RICHLAND COUNTY
BOARD OF
ZONING APPEALS

**09-04 V
Genesis Consulting Group
110 Clemson Rd. Ext.
Columbia, SC 29229
25608-01-40**

CASE 09-04 V GENESIS CONSULTING GROUP

09-04 Variance

01 CONCEPTUAL SITE PLAN
1" = 20'-0"

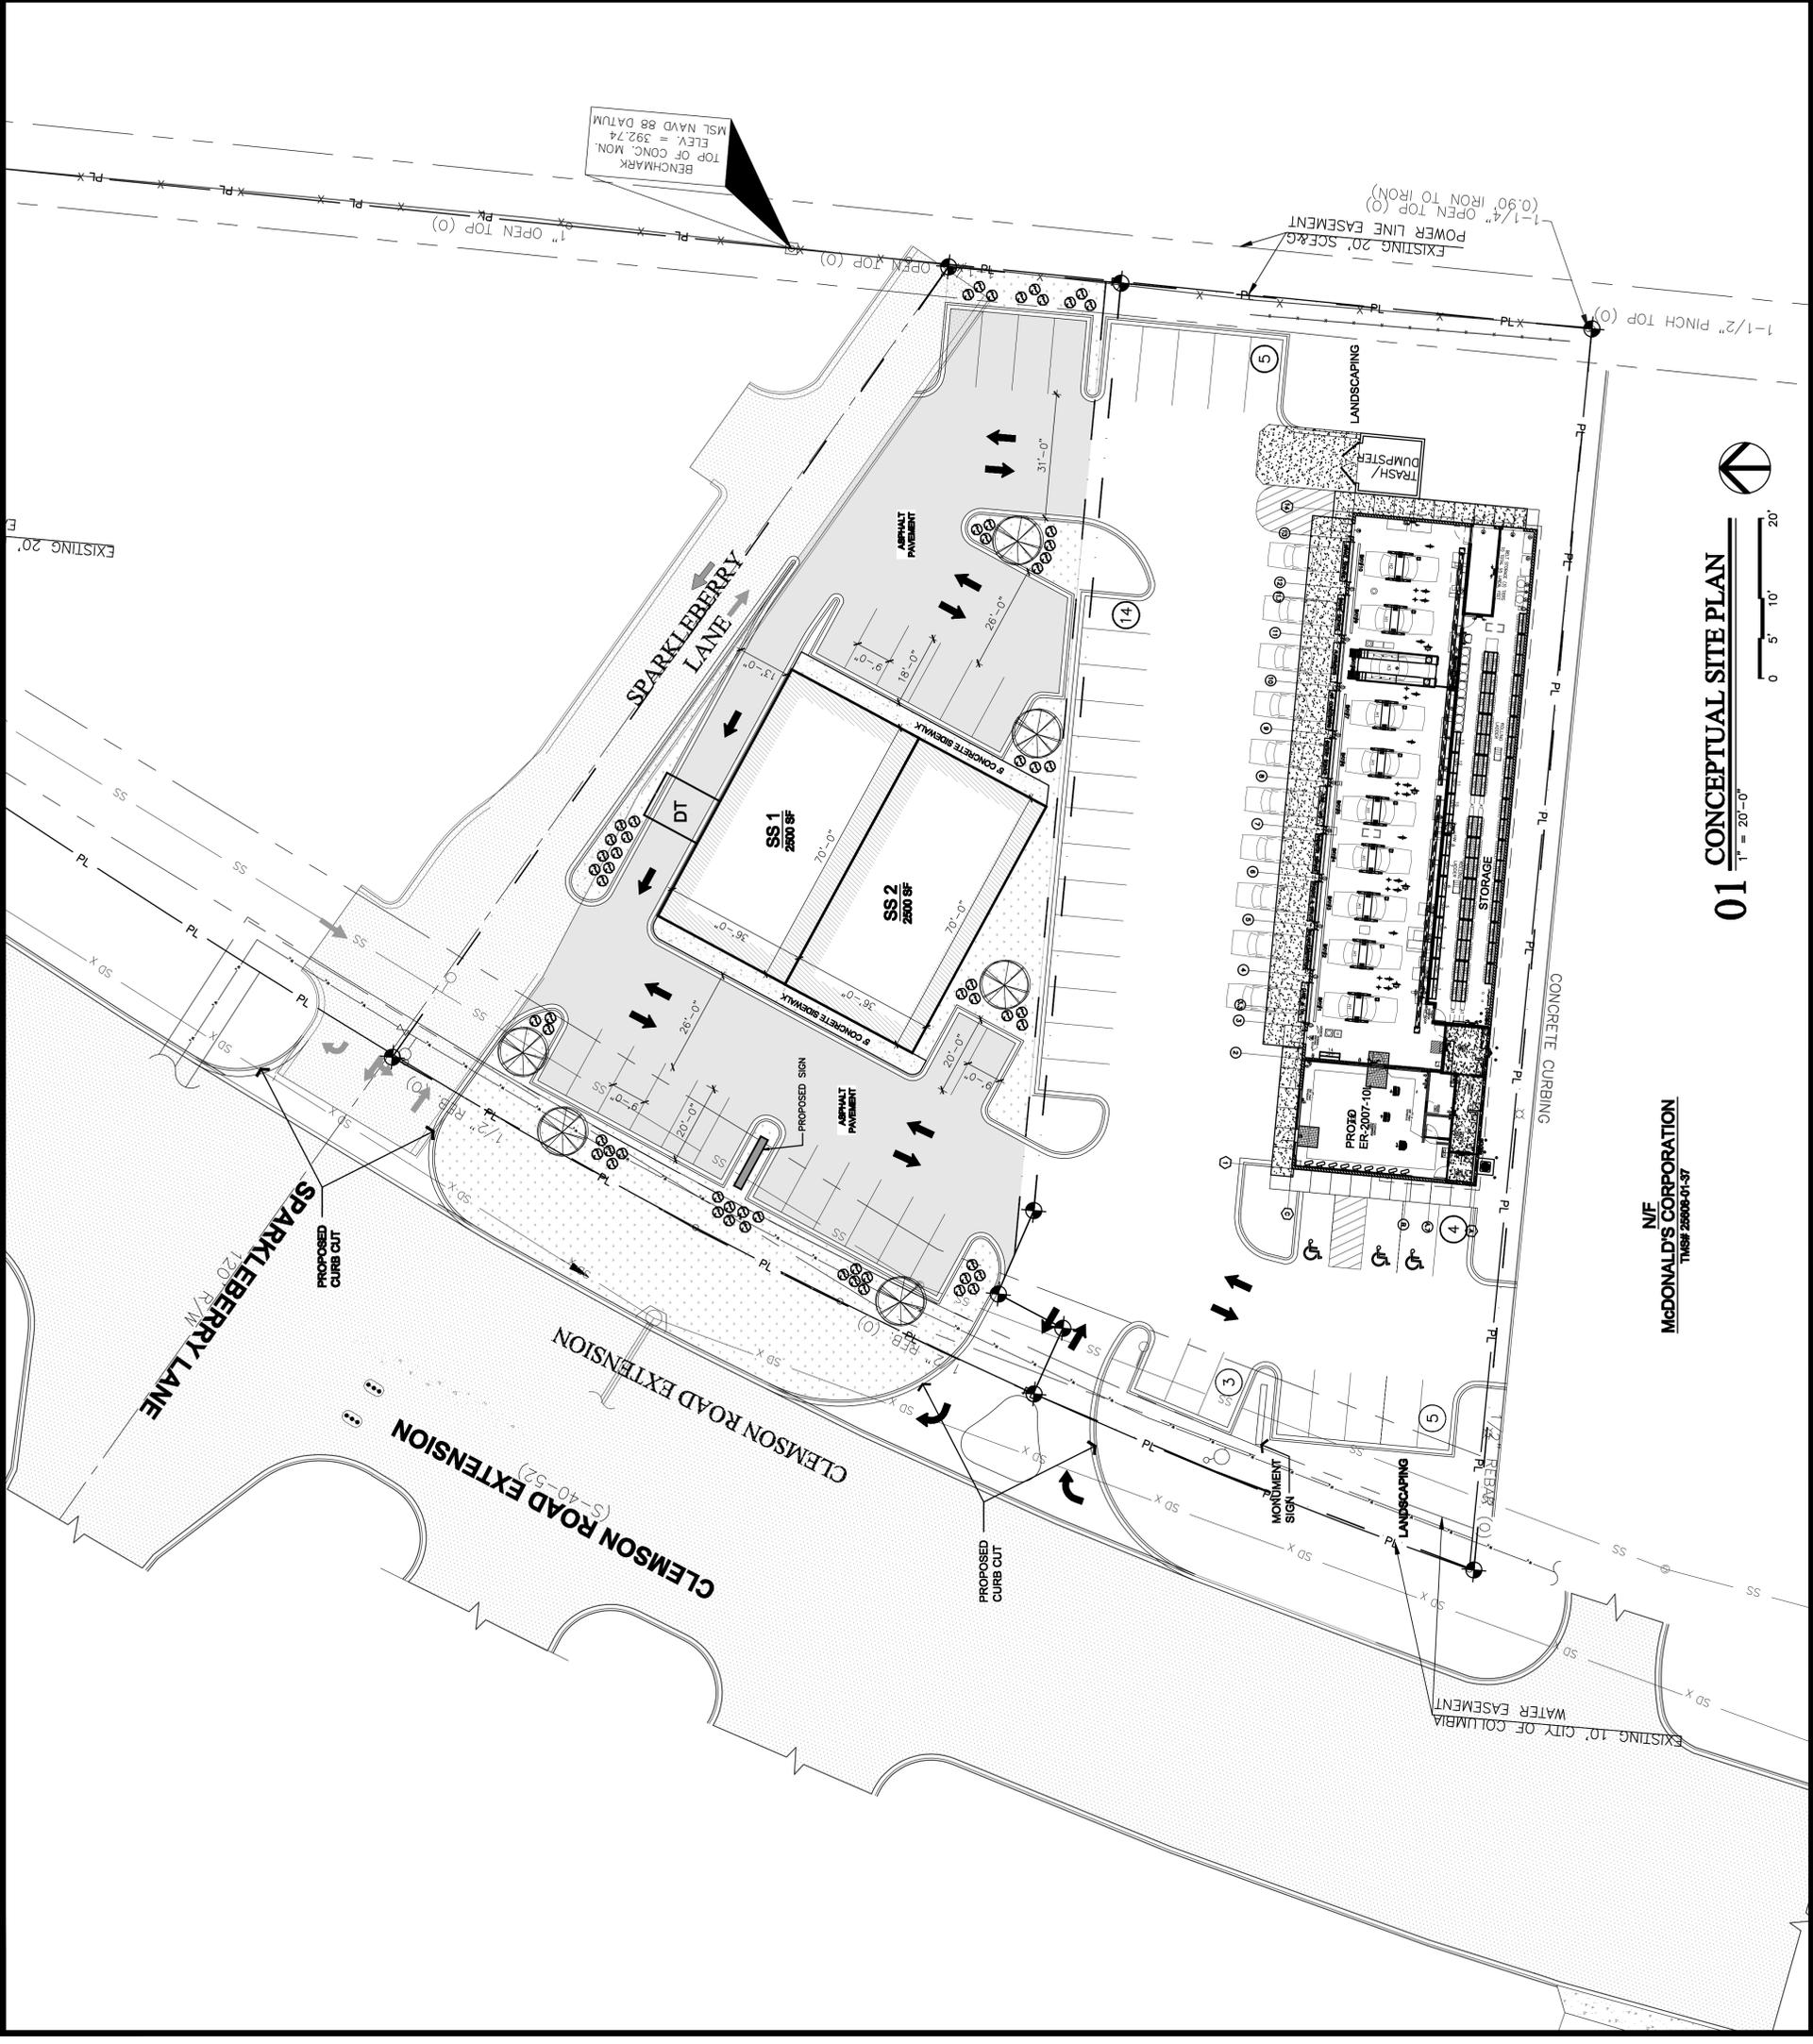
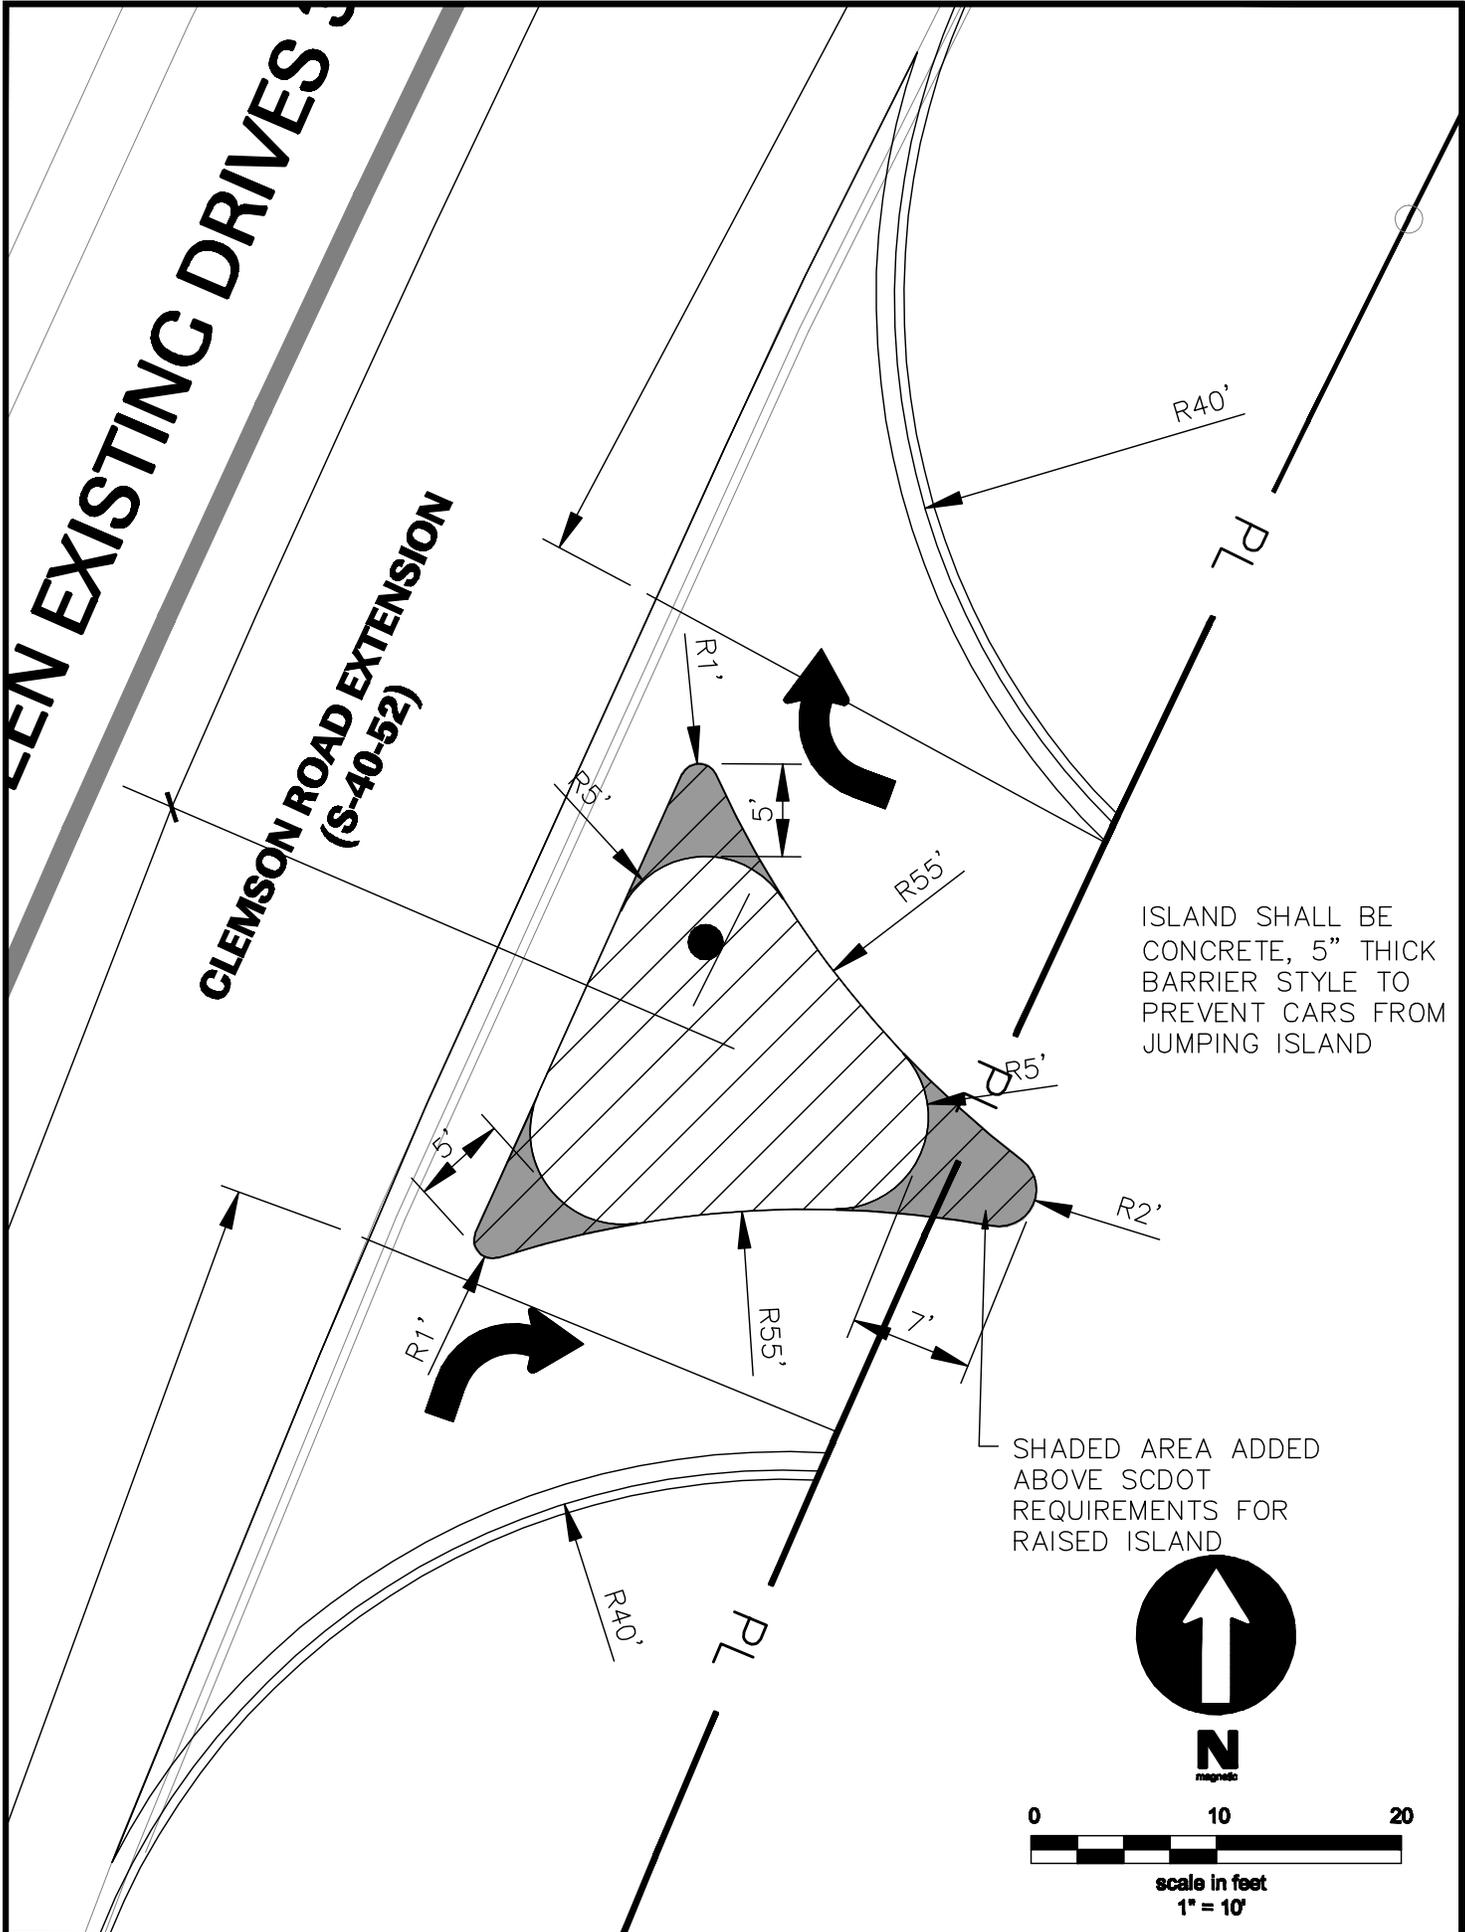
The applicant has proposed a new Right-In, Right-Out (RIRO) driveway located 150 feet from the Clemson Rd/Sparkleberry Rd intersection. This intersection is signalized. There is no median opposite the proposed RIRO to prohibit left turns into the site from Clemson Rd.

The PSDS has repeatedly advised the applicant that we will not approve a site plan, regardless of the RIRO decision, unless it identifies all types and the respective amounts of development on the whole site. We have also repeatedly advised the applicant that we will not accept two entrances onto Sparkleberry Lane, particularly since one of the proposed driveways is only 40 feet from the Clemson Rd right-of-way.

Based on the findings of fact discussed above, the variance should be **denied** because the applicant has not demonstrated compliance with the conditions required to grant a variance.
